**Addendum #1**  
**2020 Roadway Improvement Project**  
**“Cambridge Drive Neighborhood”**  
**Bid No. 20-15**  
**Town of East Hartford**

**February 28, 2020**

The following summarizes the revisions to the Bid Documents included in Addendum #1 for the 2020 Roadway Improvement Project (Bid No. 20-15).

NASSAU LANE AT HOLLISTER DRIVE

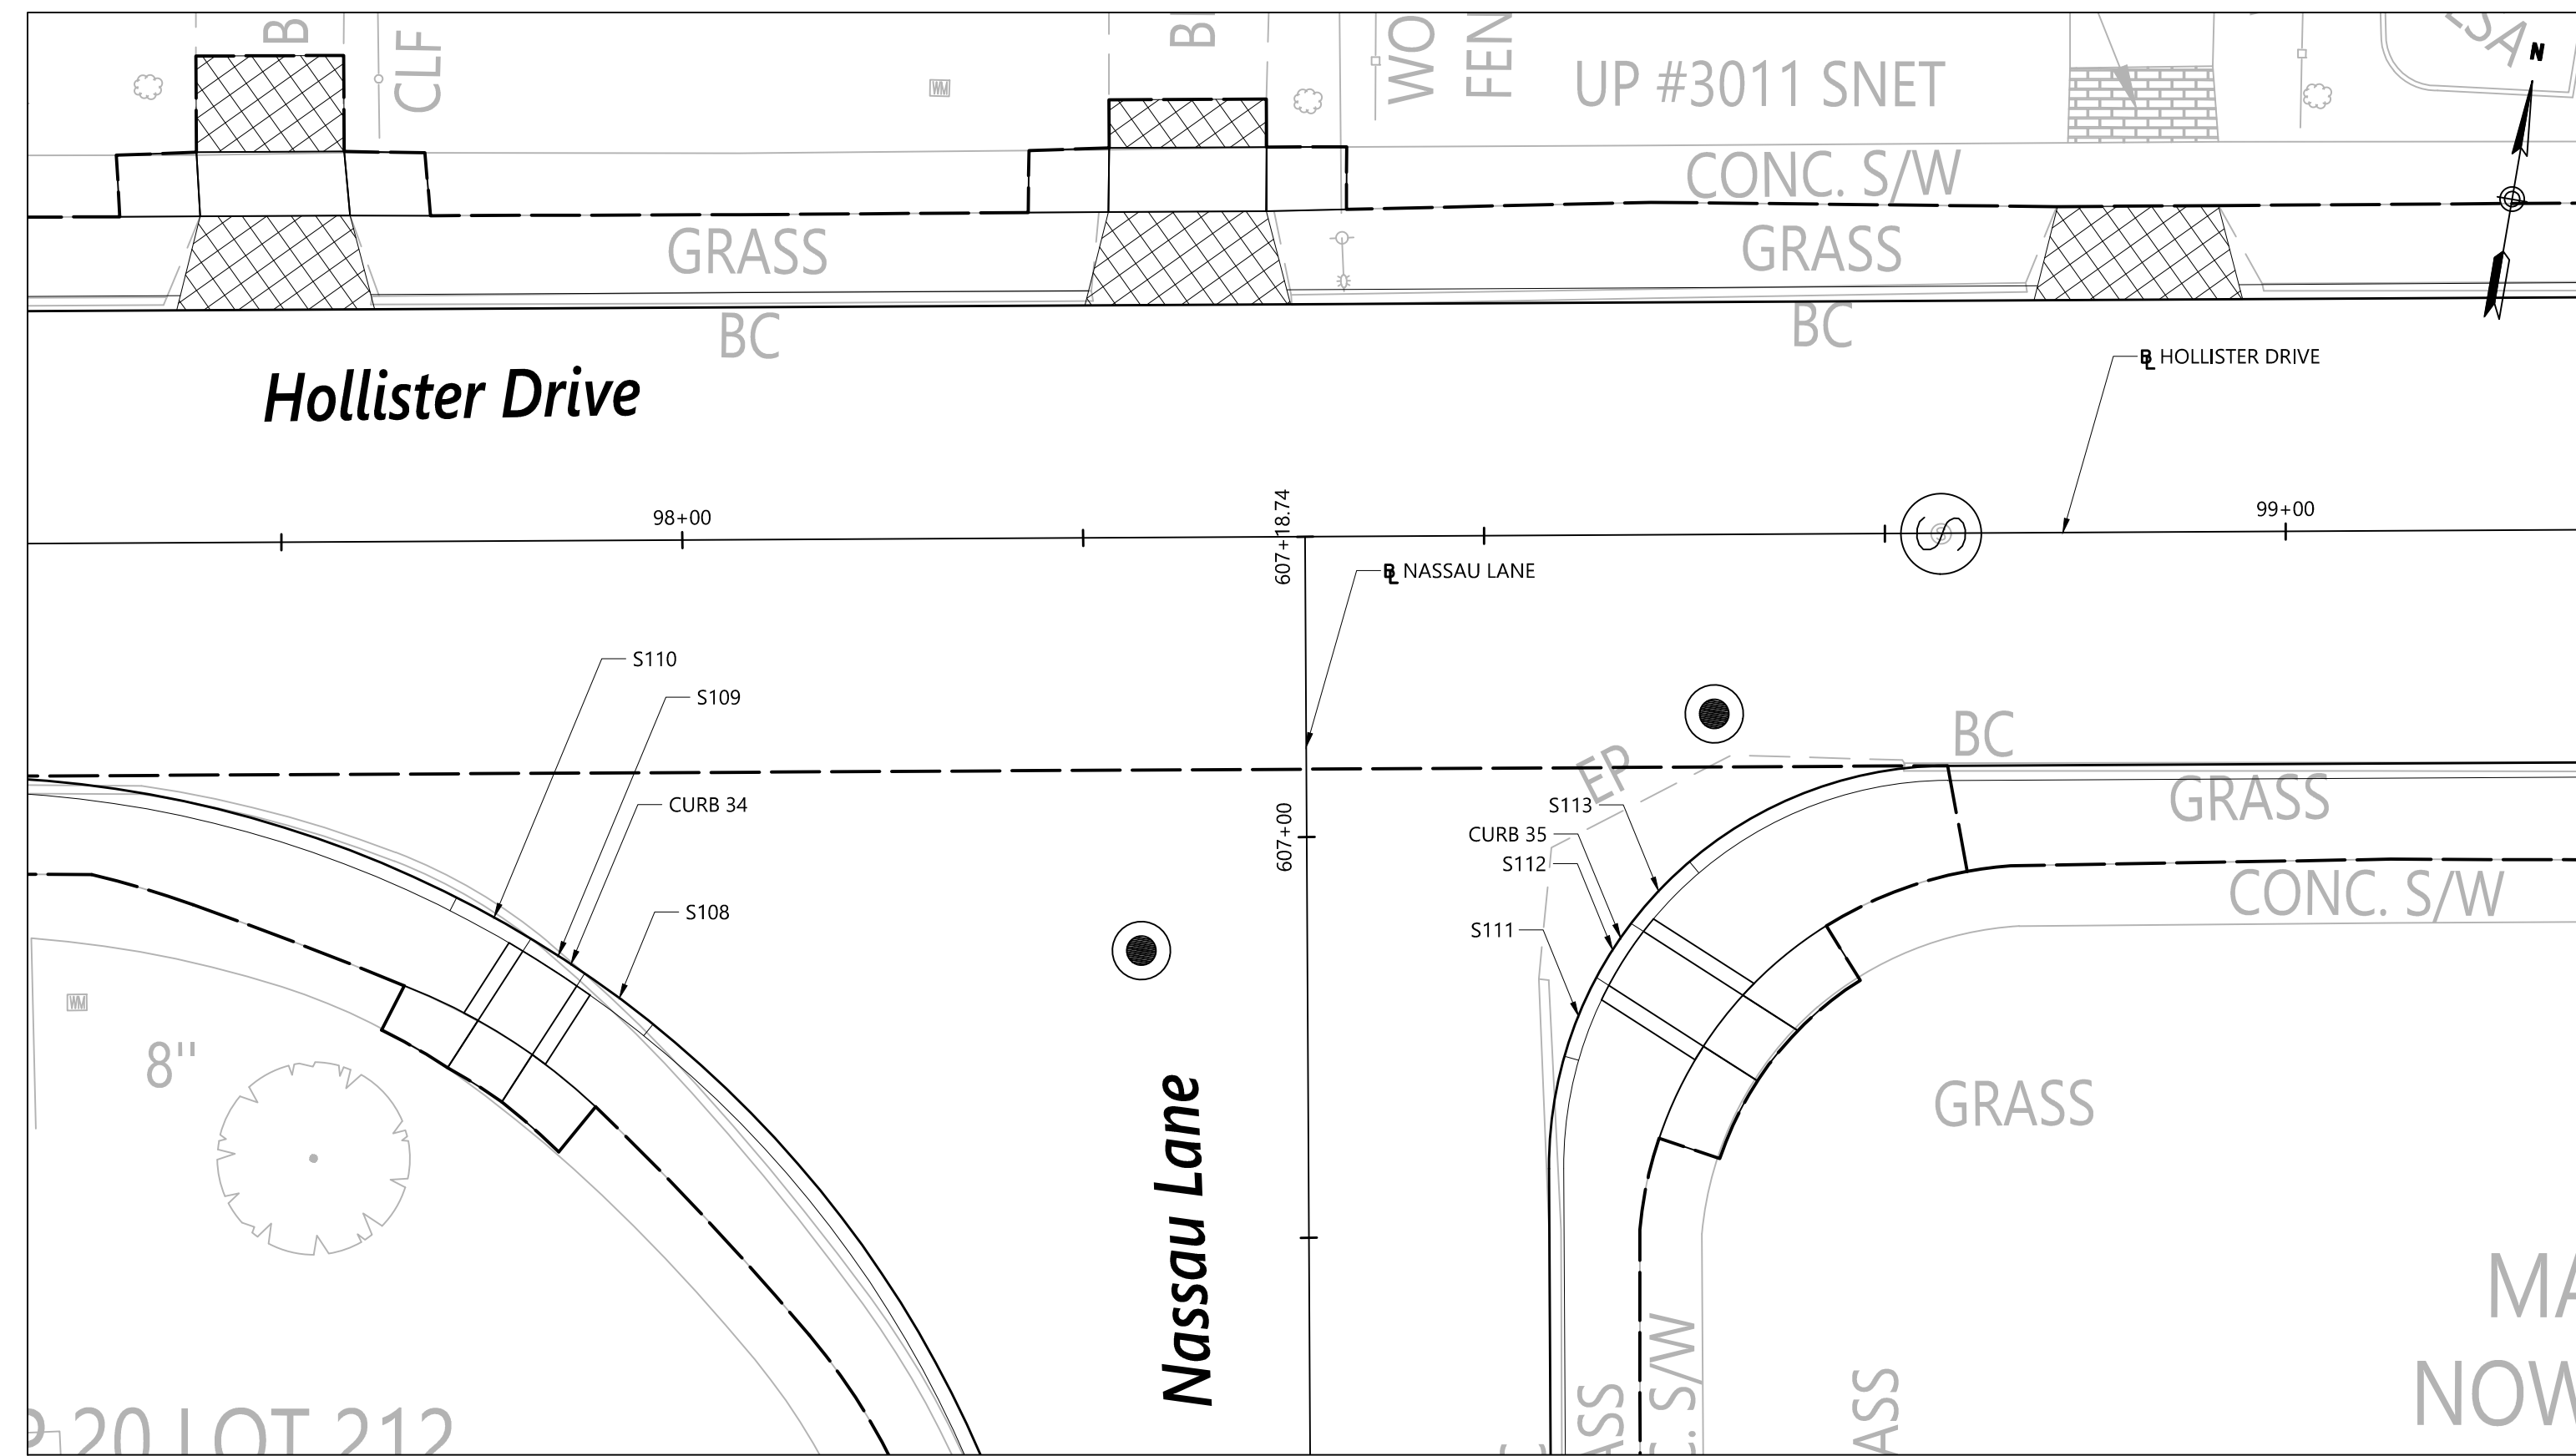
- Replace plan sheet 072 of 294 to reflect revisions to sidewalk ramp layout, curb layout, granite curb table, and calloffs.

REV.	DATE	DESCRIPTION	SHEET NO.
02/27/20	REVISED RAMP AND CURB LAYOUT, CURB TABLE, AND CALLOFFS	072

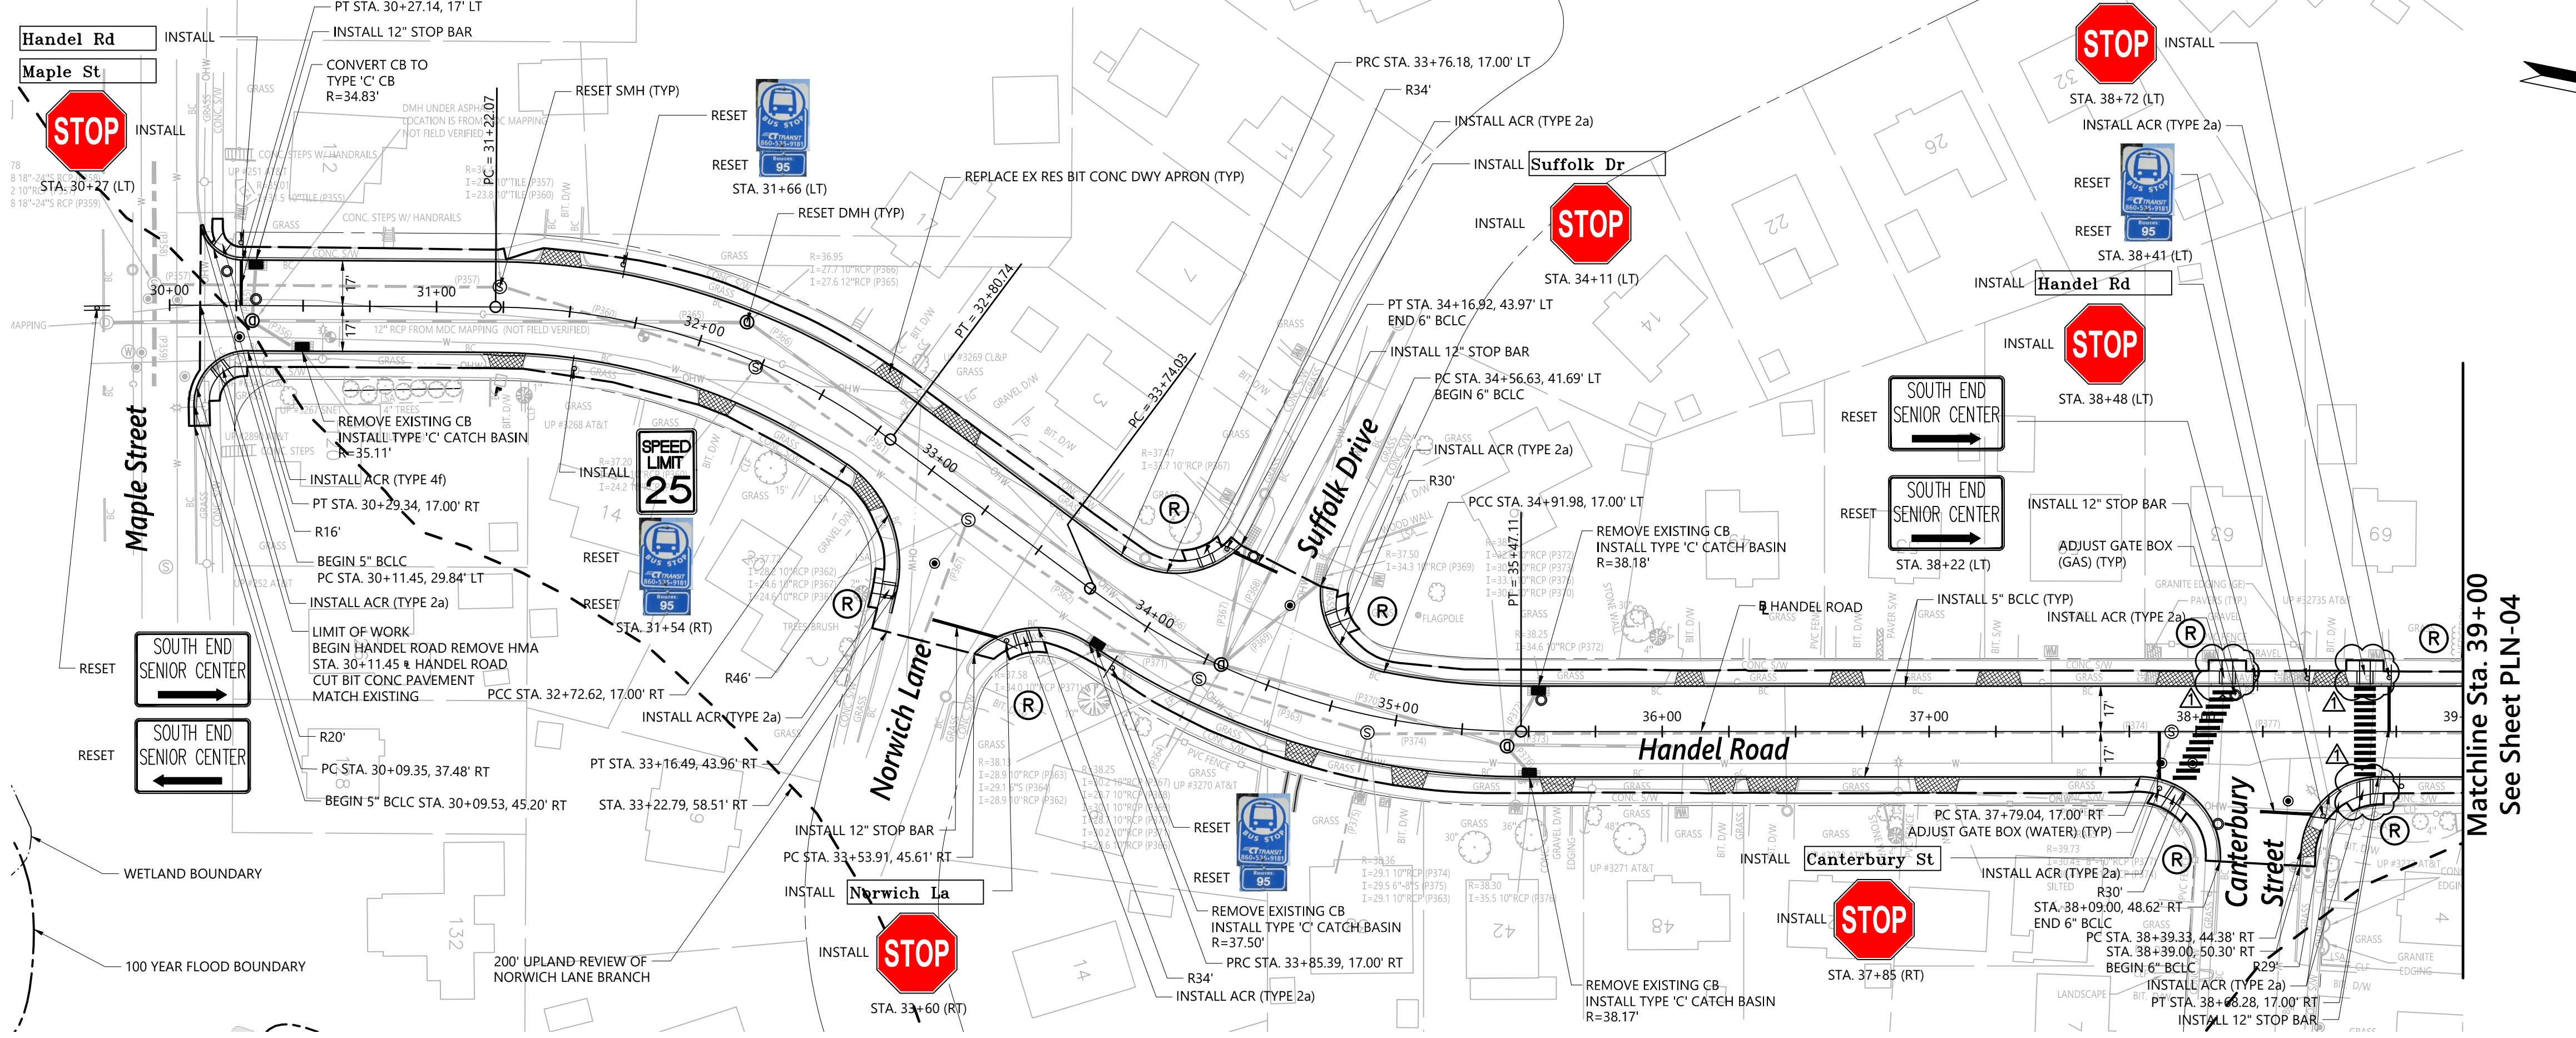
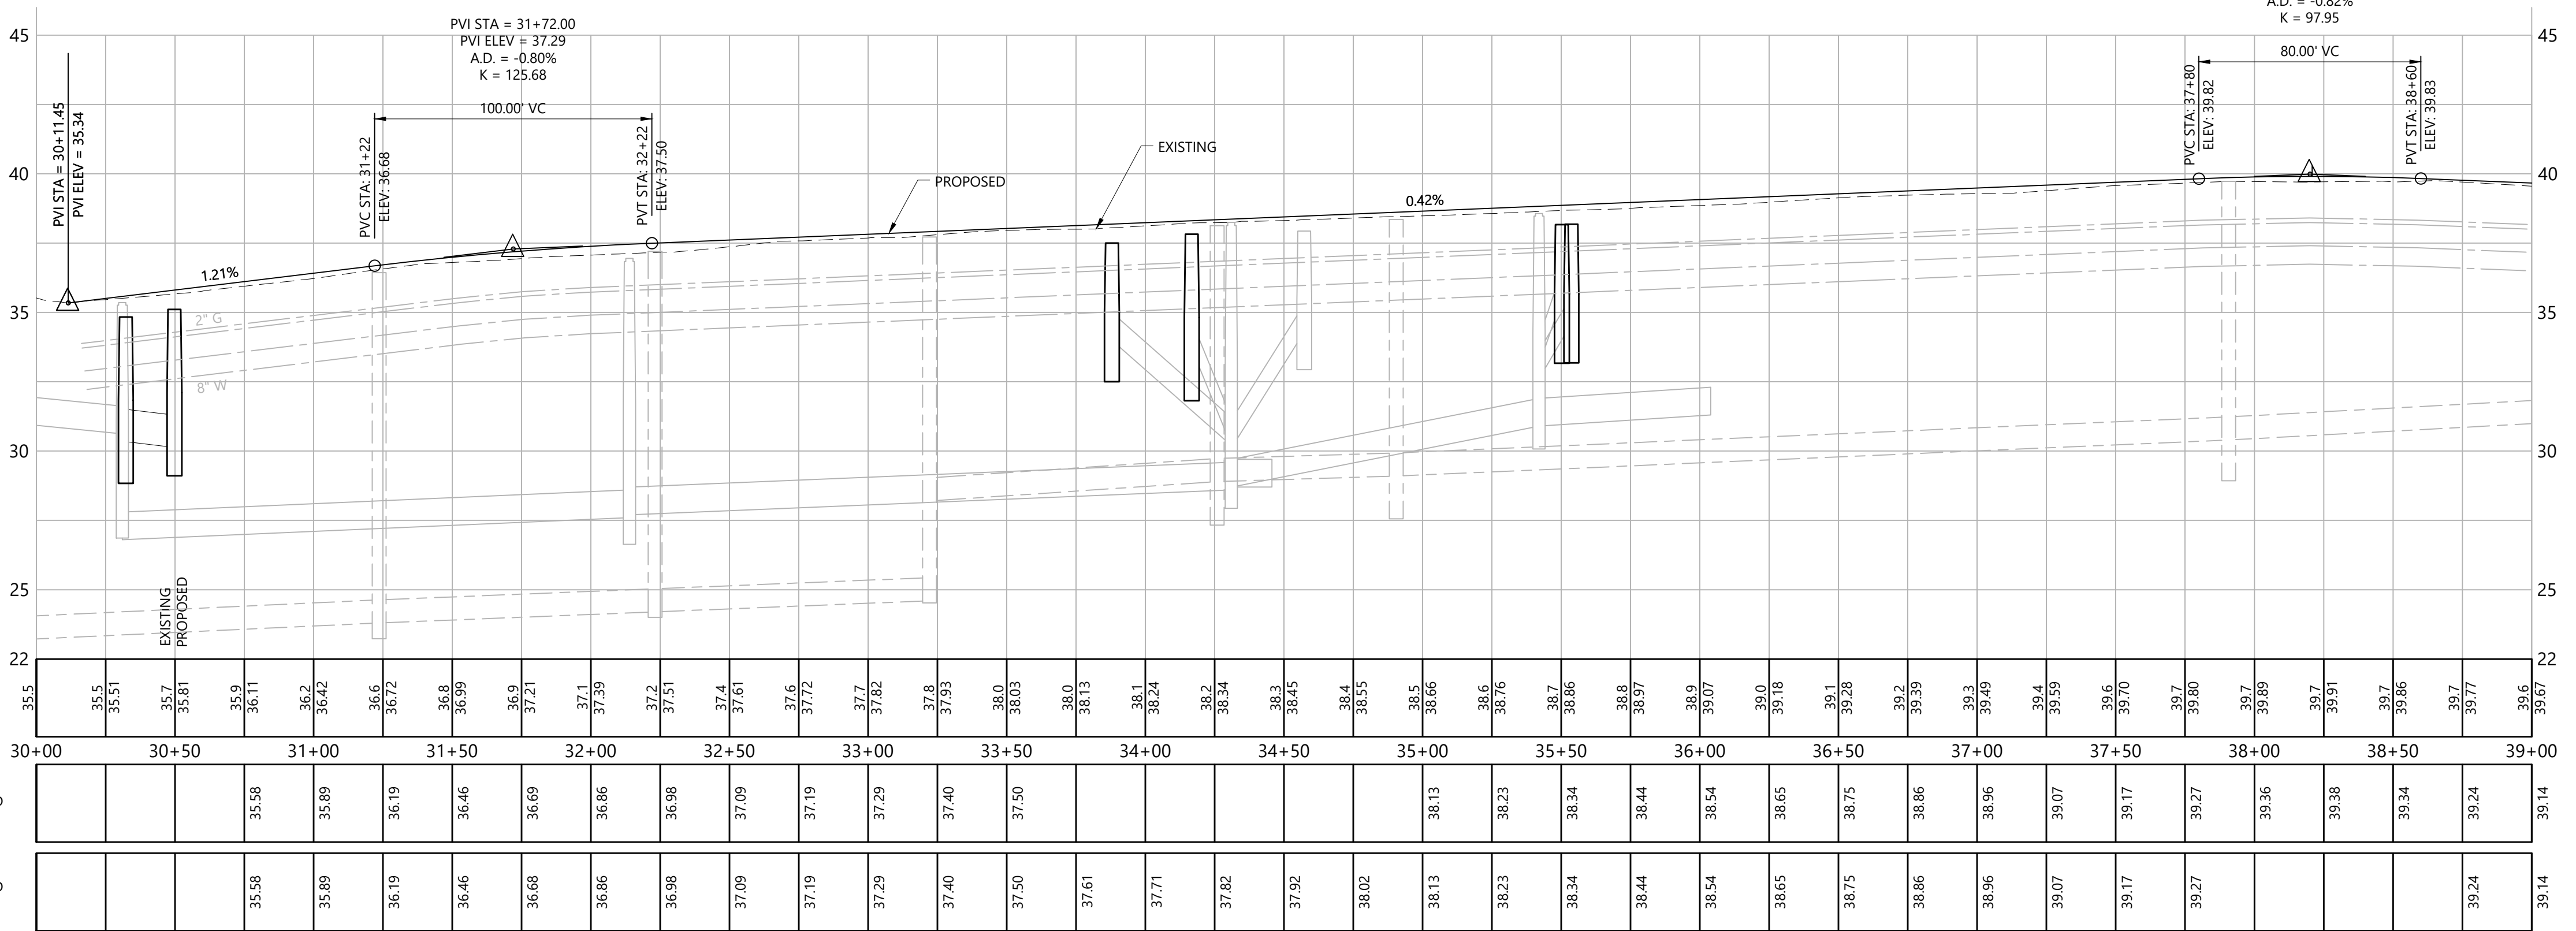
- Replace plan sheet 078 of 294 to reflect revised sidewalk ramp layout and curb layout.

<p>DESIGNER: JRE</p> <p>DRAFTER: TJM</p> <p>CHECKED BY: BAA</p> <p>APPROVED BY: SON</p>	<p><b>Engineers Scientists Planners Designers</b></p> <p>ISSUED FOR CONSTRUCTION DATE: JANUARY, 2020</p>	<p>PROJECT TITLE:</p> <p style="text-align: center;"><b>CAMBRIDGE DRIVE NEIGHBORHOOD ROADWAY IMPROVEMENT PROJECT VARIOUS LOCATIONS</b></p> <p>CADD FILENAME: PLN-HANDEL-4241300 - ADDENDUM #1.DWG</p>	<p>TOWN:</p> <p style="text-align: center;"><b>EAST HARTFORD, CONNECTICUT</b></p> <p>DRAWING TITLE:</p> <p style="text-align: center;"><b>CONSTRUCTION PLAN HANDEL ROAD</b></p>								
<table border="1" style="width: 100%; border-collapse: collapse;"> <tr> <th>REV.</th> <th>DATE</th> <th>DESCRIPTION</th> <th>SHEET NO.</th> </tr> <tr> <td>02/27/20</td> <td></td> <td>REVISED SIDEWALK RAMP AND CURB LAYOUT</td> <td>078</td> </tr> </table>	REV.	DATE	DESCRIPTION	SHEET NO.	02/27/20		REVISED SIDEWALK RAMP AND CURB LAYOUT	078		<p>PROJECT NO.:</p> <p style="text-align: center;"><b>42413.00</b></p> <p>DRAWING NO.:</p> <p style="text-align: center;"><b>PLN-03</b></p> <p>SHEET NO.:</p> <p style="text-align: center;"><b>078 OF 294</b></p>	
REV.	DATE	DESCRIPTION	SHEET NO.								
02/27/20		REVISED SIDEWALK RAMP AND CURB LAYOUT	078
